**Subject:** Resolution of NRC Questions Regarding ALION VUEZ 30 Day Testing Program  
Status of Responses

**Table 1: ALION VUEZ CE Testing Questions**

## Alion Follow-Up Issues (11/30/07)

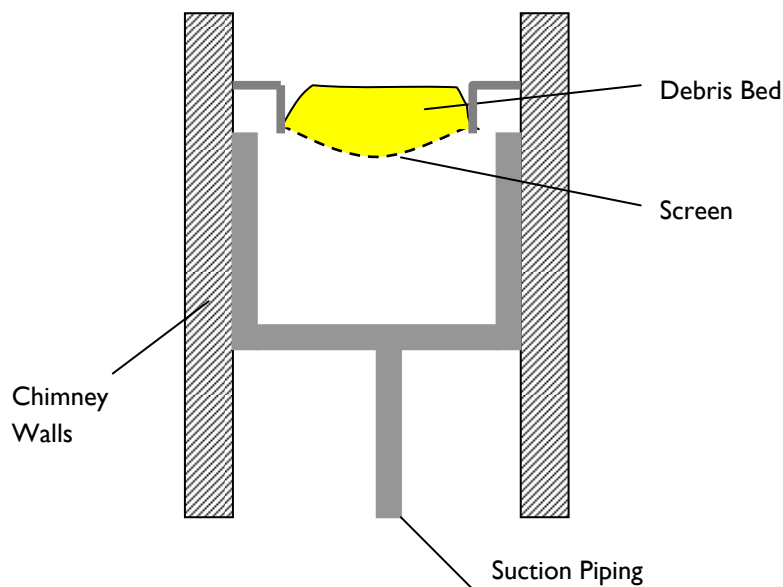
9. In two tests that were completed during the staff's visit, inward warping of the upper surface of the debris bed away from the walls of the "chimney" was observed, as shown below in an idealized cross section (not to scale). Such warping of the debris bed could result in a significant amount of the flow passing through the thinner cross section of the debris bed nearest the chimney walls.
